SERVICE BULLETIN

M-1229

REVISED BATTERY TERMINAL SCREW AND TORQUE

Figure 1. Battery Flange Screw

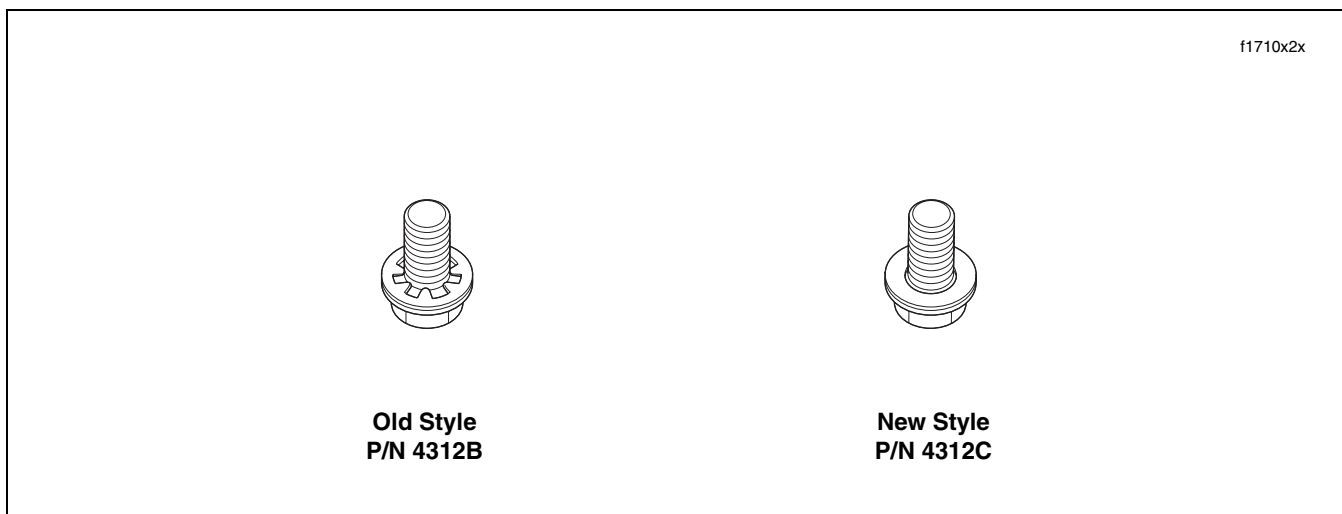
The purpose of this bulletin is to inform the dealers that Harley-Davidson Motor Company has made a change to the battery terminal screw used on all AGM batteries. The captive star washer has been replaced with a flat washer thereby changing the final torque of the fastener.

- The new battery flange screw is part number 4312C and replaces part number 4312B.

- When using the battery terminal screw with the new flat washer, tighten fasteners to 60-70 in-lbs (6.8-7.9 Nm).
